**City of Santa Barbara**  
Planning Division

**Memorandum**

**SUBJECT:** Suspension of Staff Hearing Officer Approval decision regarding  
819 Garden Street

819 GARDEN STREET – HLC REVIEW COMMENTS

FLOOR PLANS

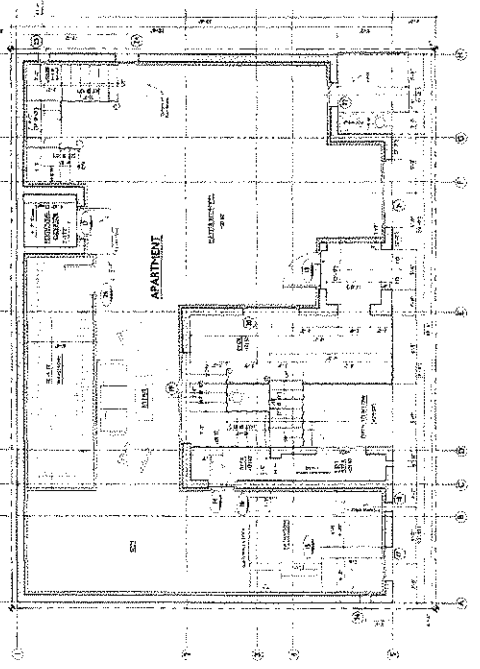
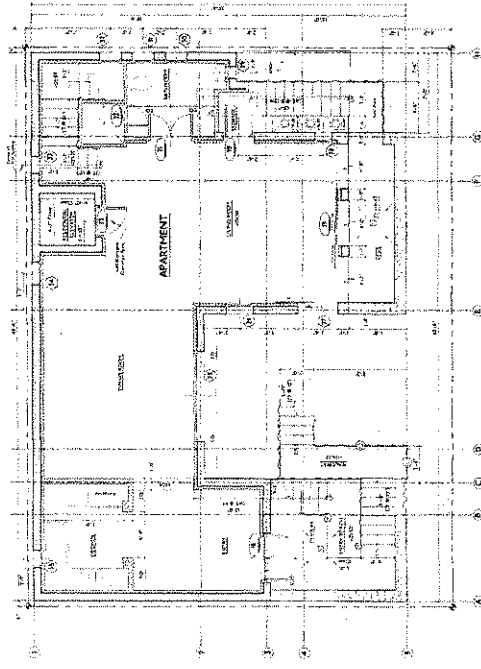
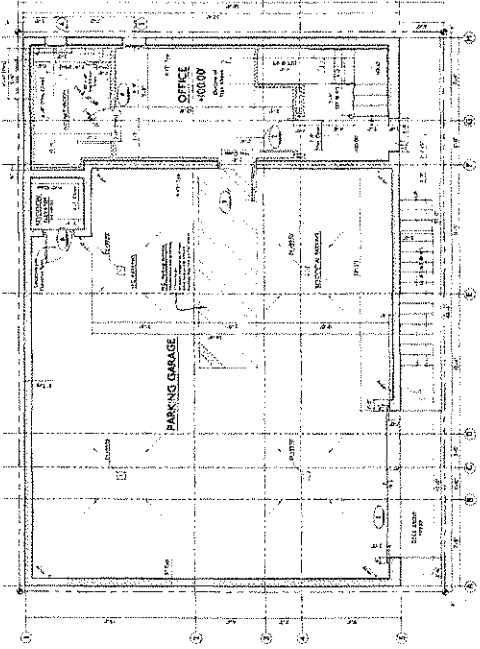
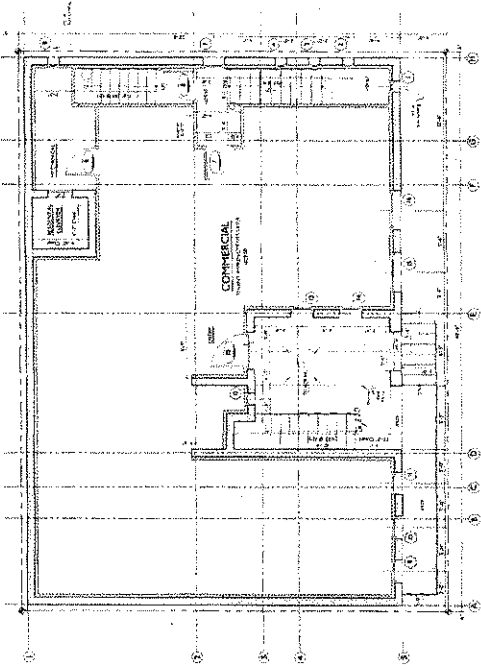
- ① Sheet Index shows (14) sheets - only (4) are submitted A1.0, A2.0, A2.1, A3.0 and the Received Set should reflect only 4 sheets being considered by Mod. officer.
- ② Needed Off-Site Parking Spaces were not noted on the Master Application or Public Notice nor attached as noted on Scope of Work (Sht A1-0)
- ③ Grading is "0" Cubic yards Do you believe this?
- ④ H.C. Parking; How does the HC gain access to the 2<sup>nd</sup> Floor Commercial? Where are the required clearances for access?
- ⑤ Window openings of 4<sup>th</sup> Floor (South) are they rated openings or Transparent IHR Walls?

1. Our "Sheet Index", located on sheet A1.0, is indicative of an ongoing and growing submittal set for the Planning Department, and ultimately, the Building Department. Sheets submitted for this modification hearing and review are as requested by the Planning Department and reflect only a portion of the current state of the project. A more comprehensive set is available upon request.

2. Deeded "Off-Site Parking" has been previously submitted to the Planning Department, and is part of the Public Record. Sheet A1.3 of the more comprehensive set contains a reproduction of said agreement, and is available upon request.

3. The stated "Grading Quantity" is reflective of proposed earthwork outside of the building footprint. The project site is effectively flat (<1%) and as indicated in the submittal set, will be almost entirely covered by the proposed building. Quantities are as follows: lot - 1881 sf (100%), building footprint - 1666 sf (89%), pavement - 117 sf (6%) and landscaping - 98 sf (5%).

4. Accessibility:
  - Accessible parking is located on the ground floor, as is the accessible portion of the single-tenant commercial space.
  - The accessible bathroom is located on the first level and required clearances are dimensioned.

- The proposed commercial space is comprised of two same-use spaces; one on the ground level and the other on the second level.
  - This design was reviewed with the Building Department and deemed feasible per Building Code Section 1103B, Exceptions 3.1 & 3.2.

- The Building Department will continue to review this item for compliance through the building permit application process. If deemed necessary, a commercial elevator will be incorporated and an accessible bath would be added to the second floor. No changes to the exterior elevations would be necessary with these changes.

5. Two windows at the fourth level are not labeled with "1-Hr. Transparent Wall" as they should be. This oversight has been corrected.
  6. Sheet A1.2 of the more comprehensive set contains the survey of the subject property. This is available upon request. Any required additional information to be included on the site plan will undoubtedly be made obvious within the normal review process.

Mod. Heating 04/23/07 Plan Comm. 09/04/07	Proposed for Project <b>STEVEN SHULEM</b> 400 East 14th Street New York, NY 10013 Steve Shulem	<b>ROOF DECK PLAN</b> <b>4.1</b>
--	--	-------------------------------------

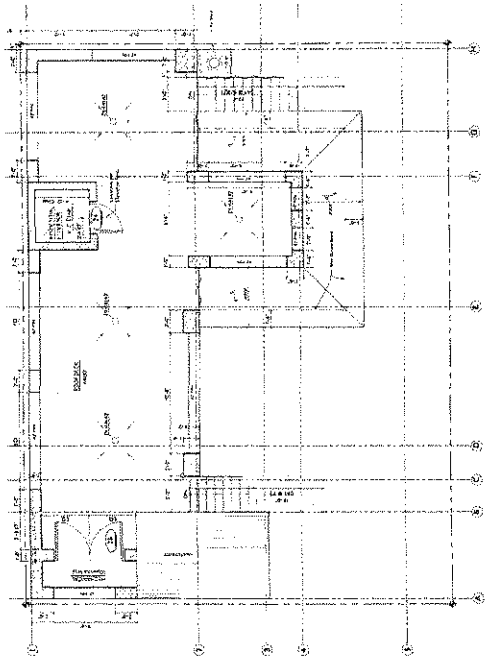
In addition, the SHO attempted to respond to some of the concerns regarding possible project impacts that were raised by the adjoining property owners. The SHO recommended that the roof deck design return to the Historic Landmarks Commission to review and consider the configuration of the roof deck so as to minimize light, air ventilation, and noise impacts to adjacent properties (Exhibit B & C).

Approved the project for off-site parking of the mixed-use project to accommodate the 10% required common open space on the roof making the findings that the Modification is necessary to secure an appropriate improvement of mixed use development on the site, and meets the purpose and intent of the Ordinance with open areas being provided in the design. The Staff Hearing Officer recommends the roof deck design return to the Historic Landmarks Commission to review and consider the configuration of the roof deck so as to minimize light, air ventilation, and noise impacts to adjacent properties.
